CONSERVATION COMMISSION AGENDA

The Conservation Commission will hold this meeting as a virtual meeting on Thursday, April 1, 2021 at 7:00 pm. No in-person meeting will take place at City Hall.

PROPOSED CONDITIONS

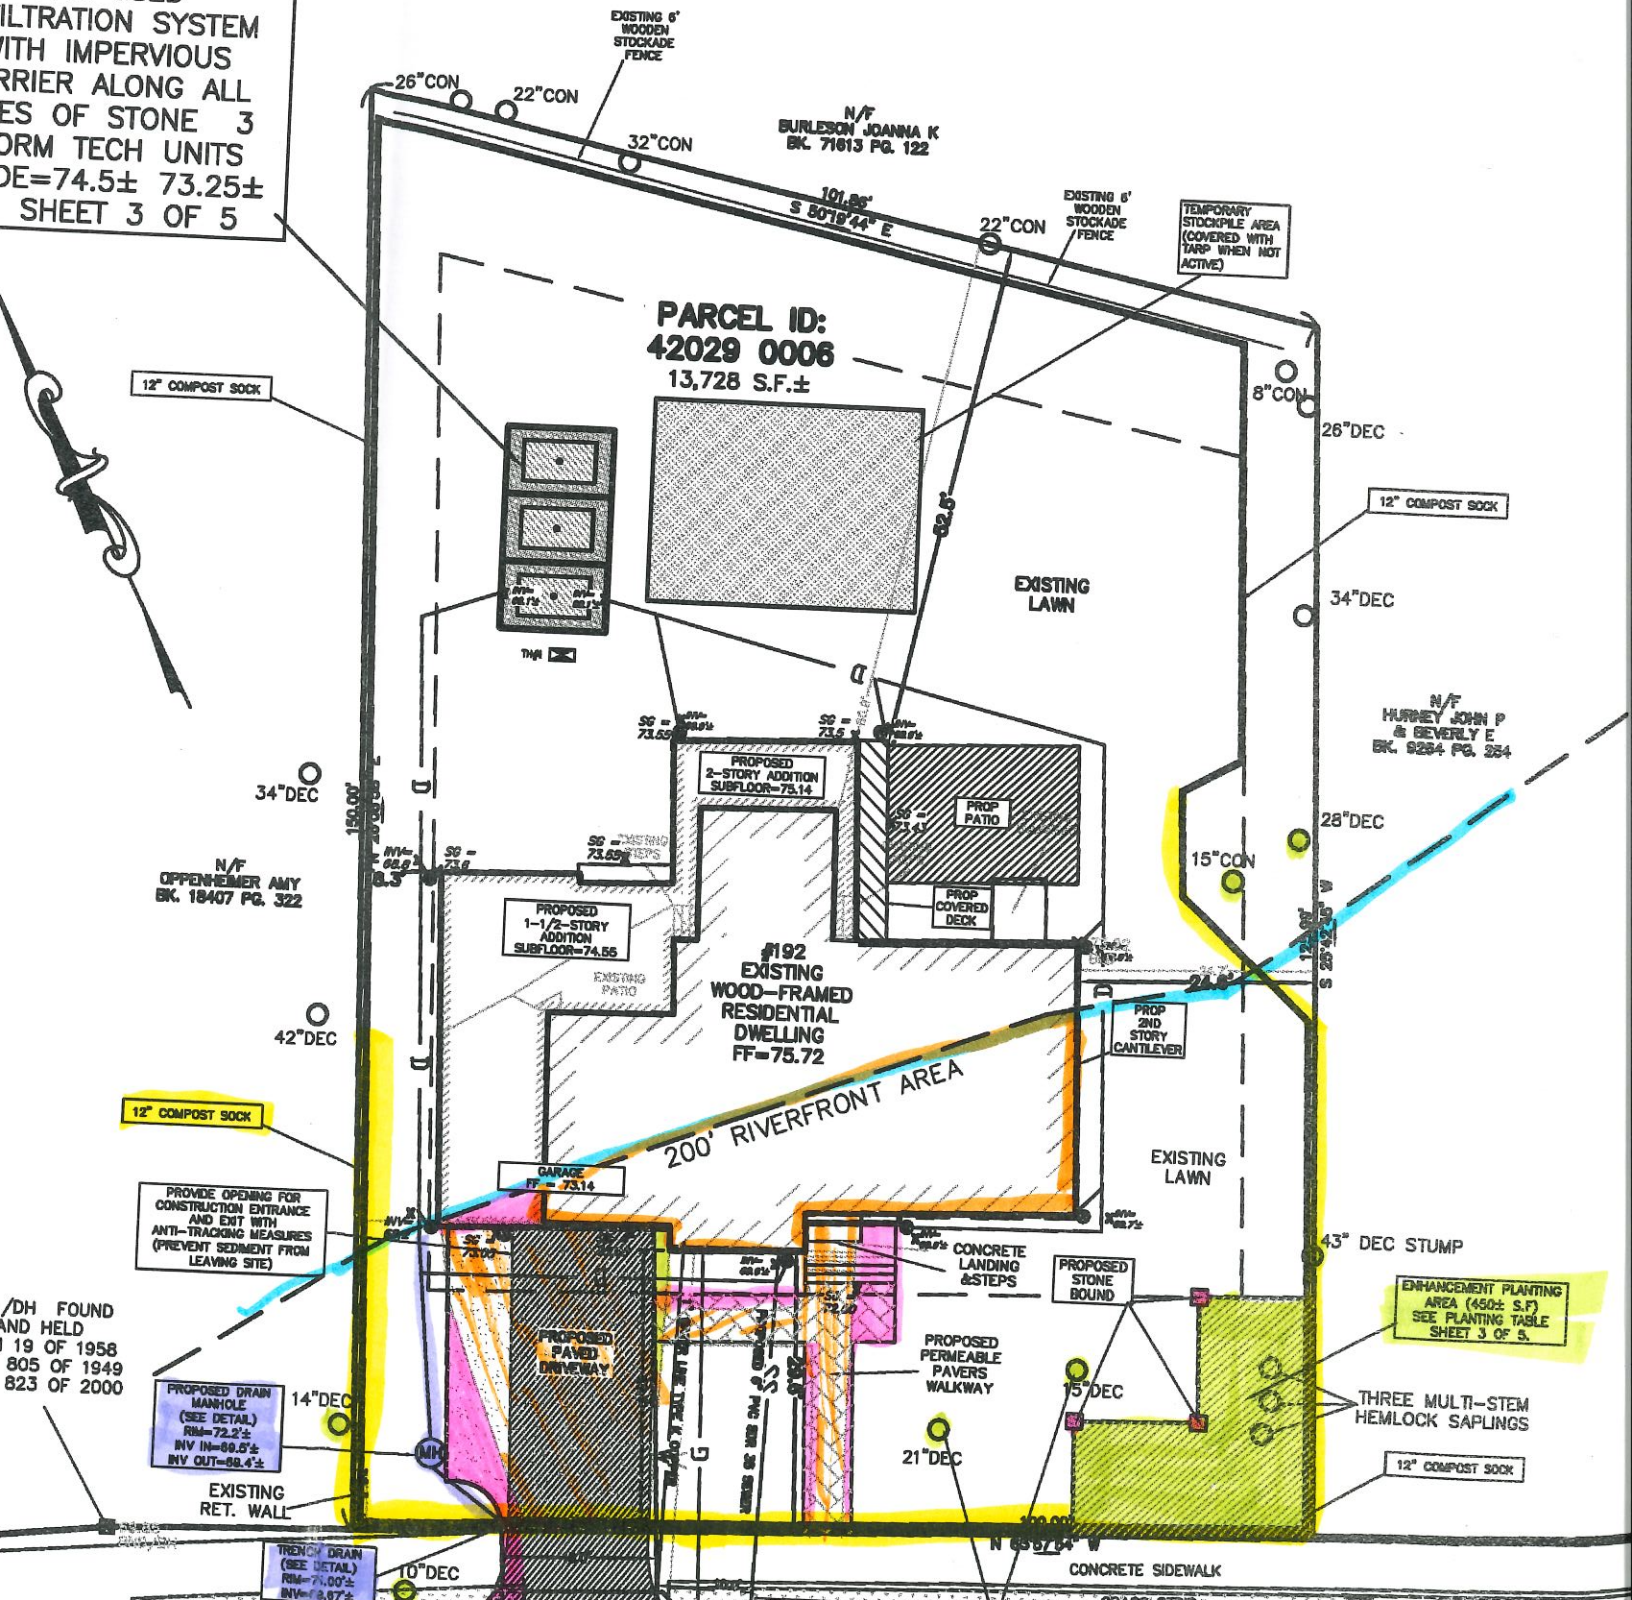
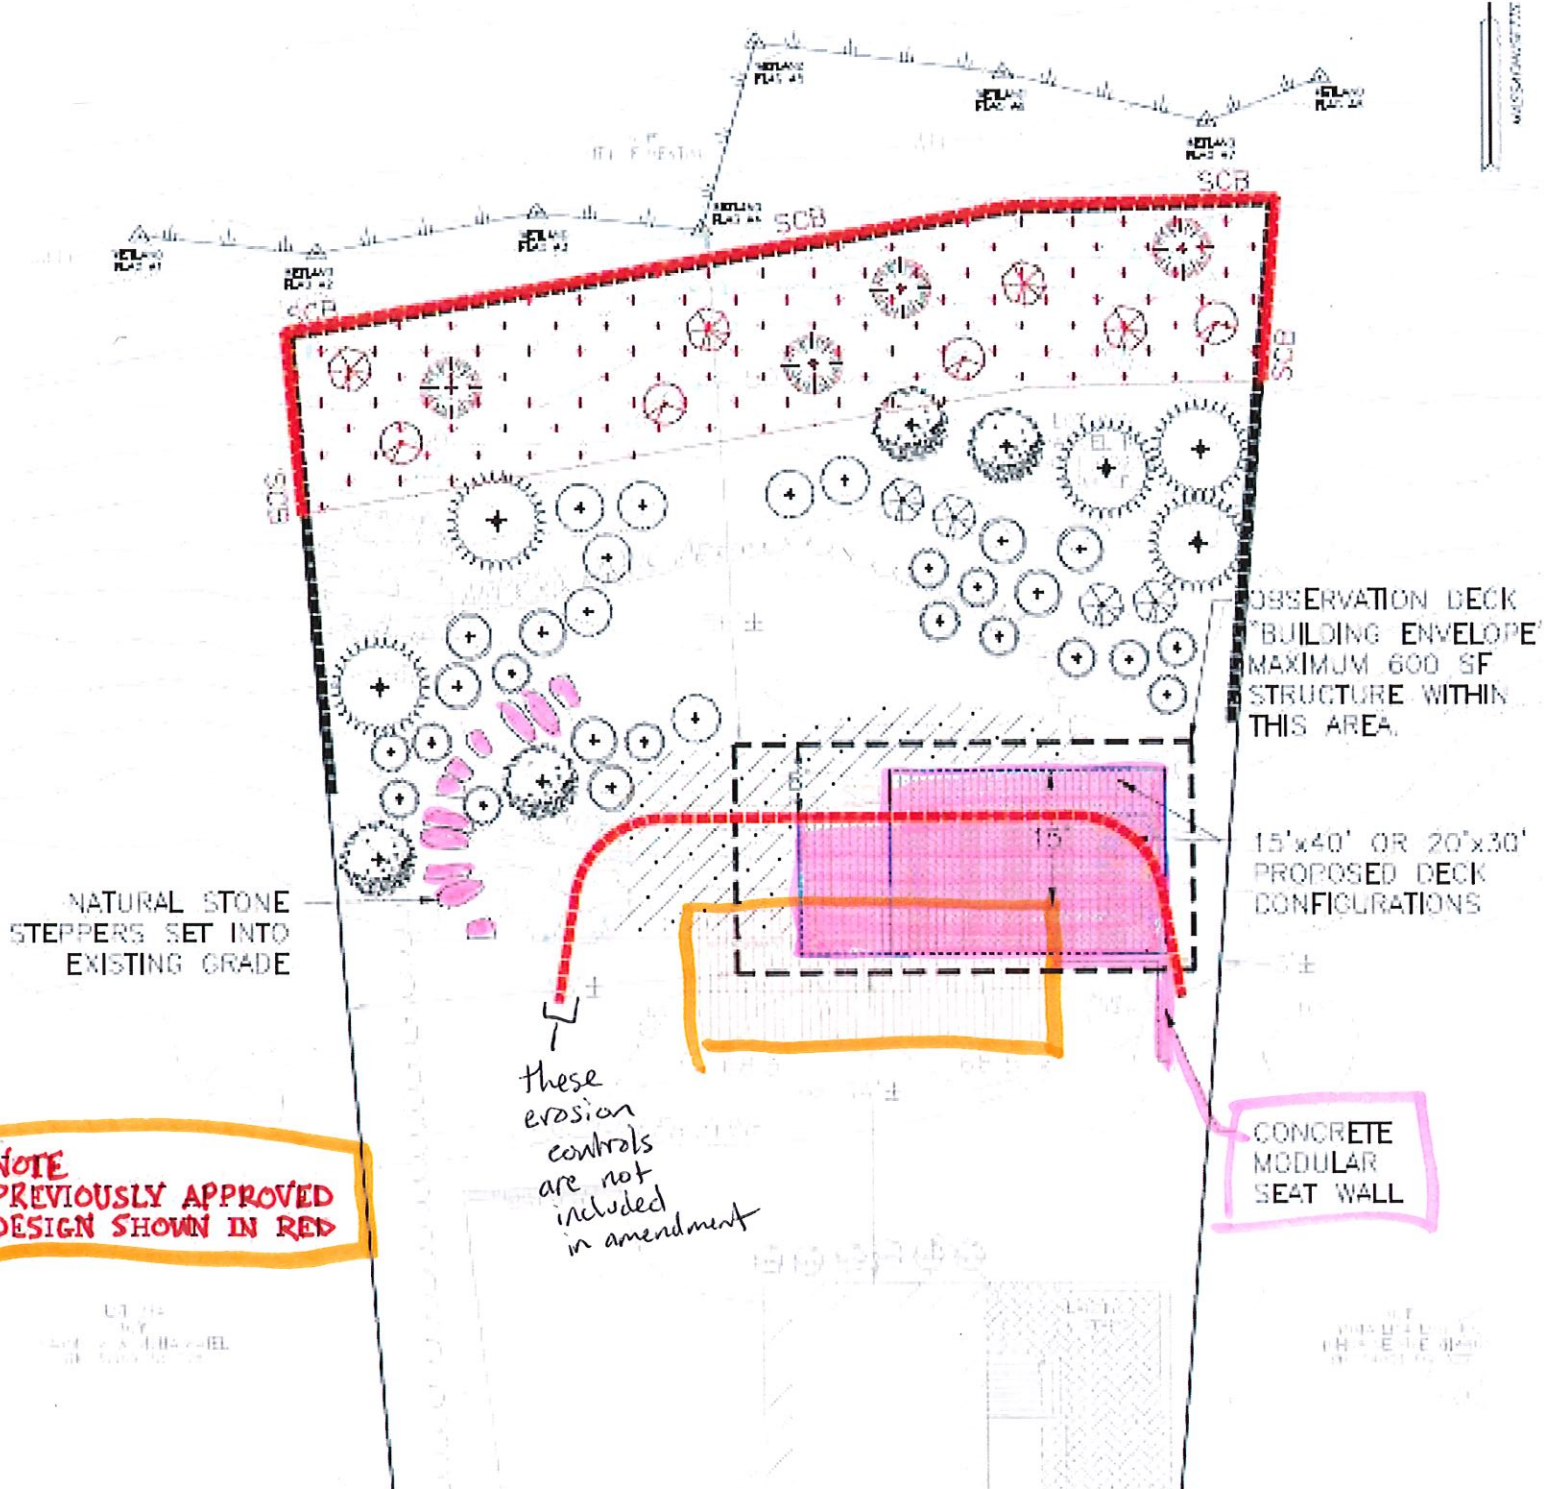
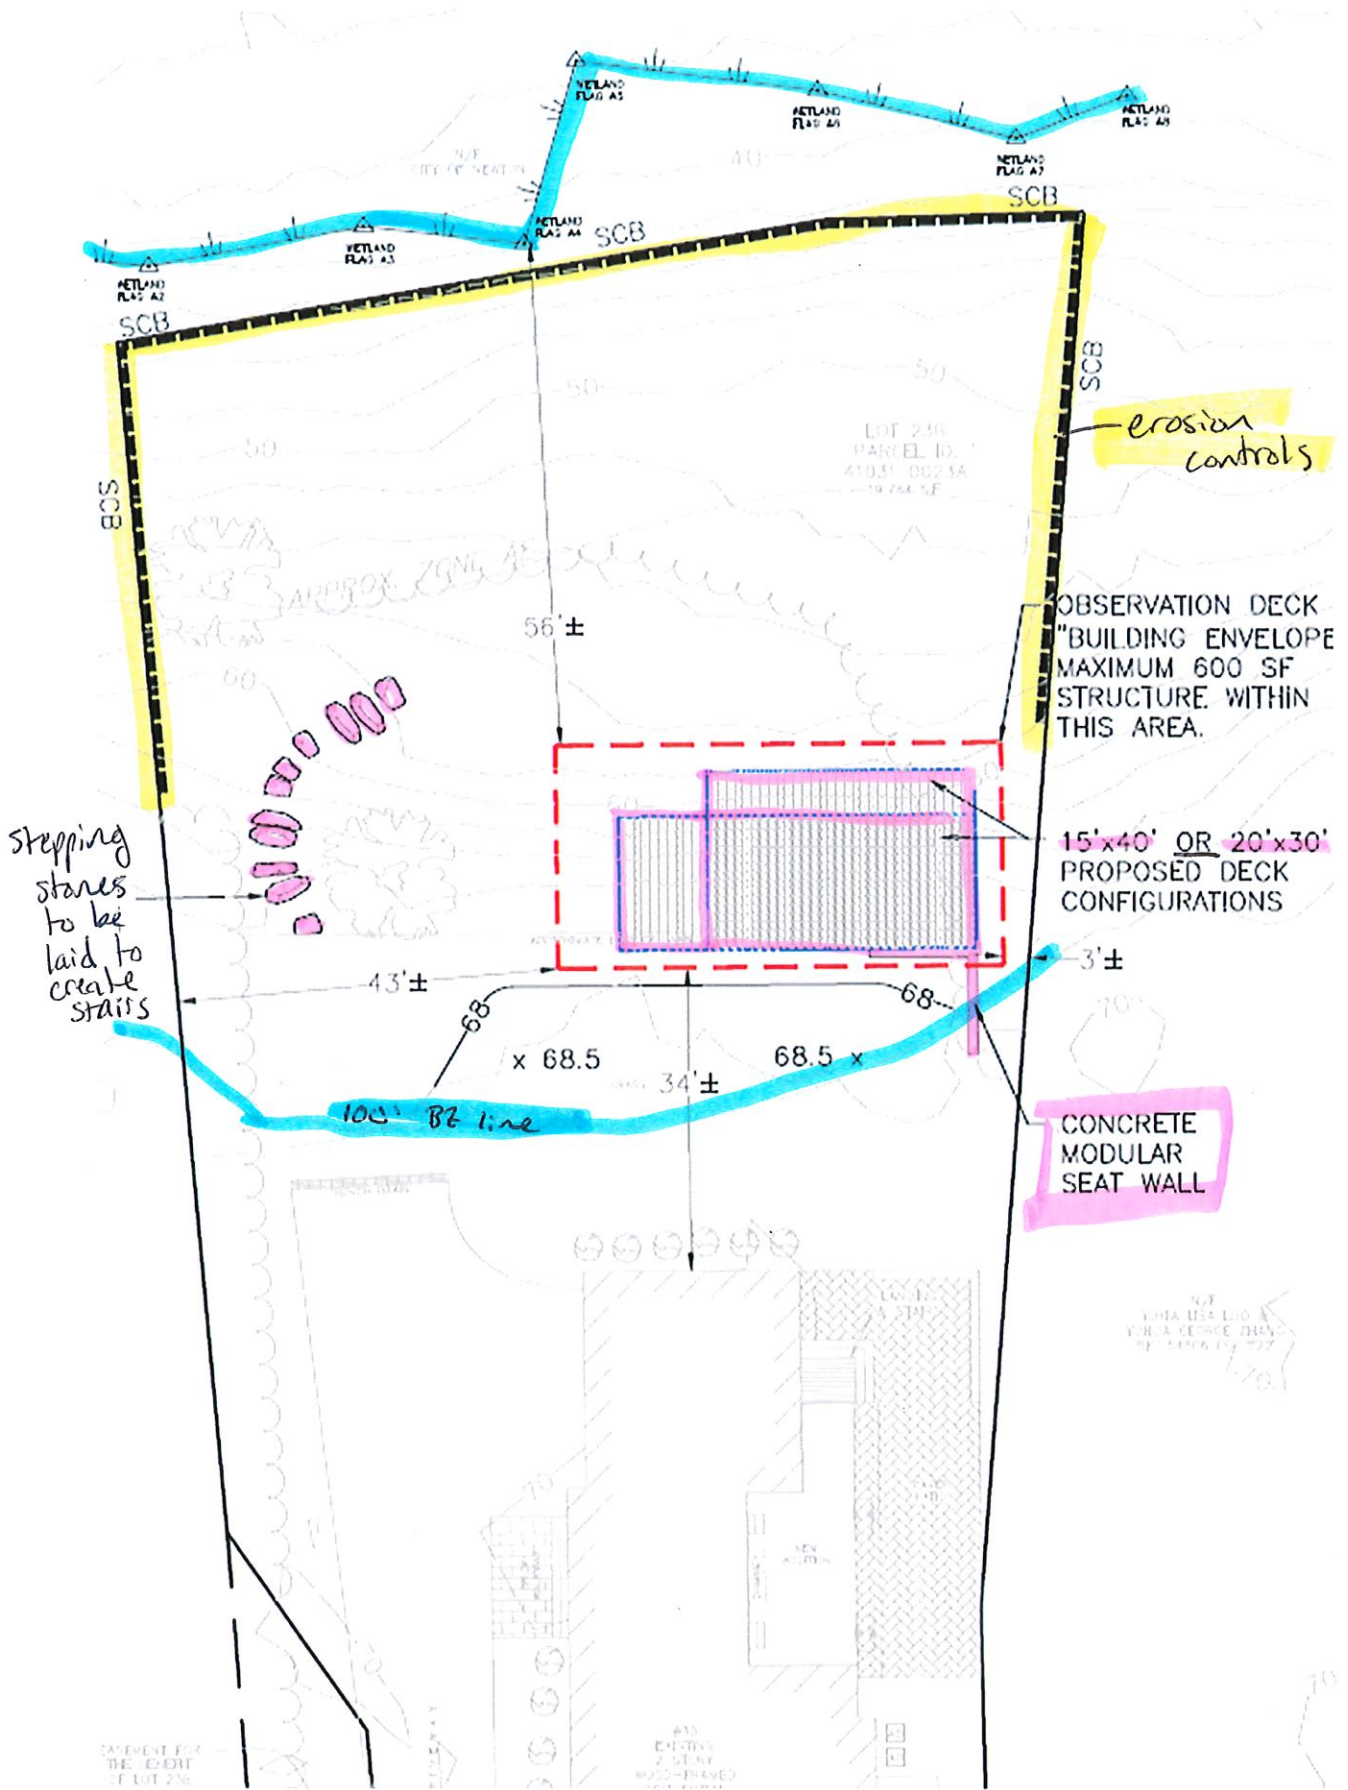
- Staff Notes:
 - Applicant should clarify whether the driveway is proposed to be expanded. The stippling and striping on the plans make the intended finished condition unclear.

- The Commission should determine whether the removal of the 43" tree must be addressed by the applicant.
 - Since 3 hemlocks with a sizable footprint are already where the mitigation area is proposed, the mitigation planting area should be expanded so that new mitigation of over 340 sf is provided.

- No tree protection is proposed for the existing hemlocks to be included in the mitigation planting area. Staff recommend requiring that the mitigation plantings be installed, the area bounded, and then additional fencing installed around it prior to other work starting on site.

- Tree protection consisting of orange, snow fence installed at the drip line of the tree must be installed on all trees proposed to remain.
 - Approved, native mitigation plantings must survive at XX% after 2 growing seasons.
